MANDATORY SERVICE BULLETIN NO. MSB 62-051 REV. 1

Model: DA 62

Replacement of the Main Landing Gear and Nose Landing Gear retaining rings.

WORK INSTRUCTION WI-MSB 62-051 REV. 1

Figure 1. MLG Retaining rings.

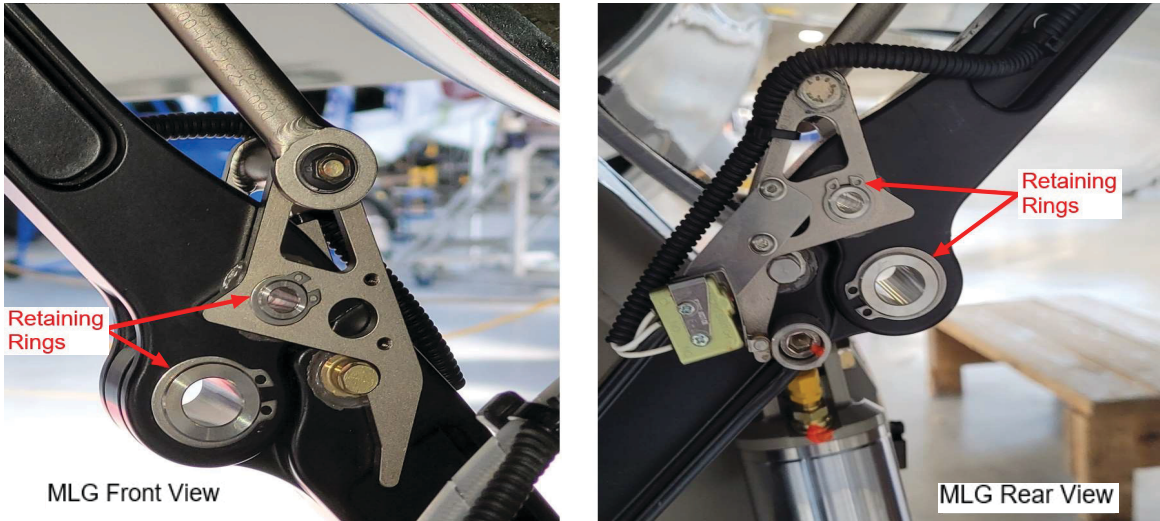
1. Pull and tag the gear circuit breaker to prevent inadvertent landing gear operation.
2. Locate the retaining rings. See Figure 1 for MLG locations and Figure 2 for NLG locations.
3. Remove the retaining rings from the MLG legs and NLG leg as per the figures (Refer to Figures 1 and 2 for location).
4. Clean the grooves of the bearing shafts. Inspect the folding stay and bearing shafts for general condition before installing the new retaining rings.

5. Using KNIPEX Circlip Pliers (or equivalent), install the new (Option # 1) retaining rings (items 1 and 2 for front and rear of the MLG and items 1 and 3 for left and right side of the NLG). Make sure the retaining rings properly engage into the grooves of the bearing shafts.
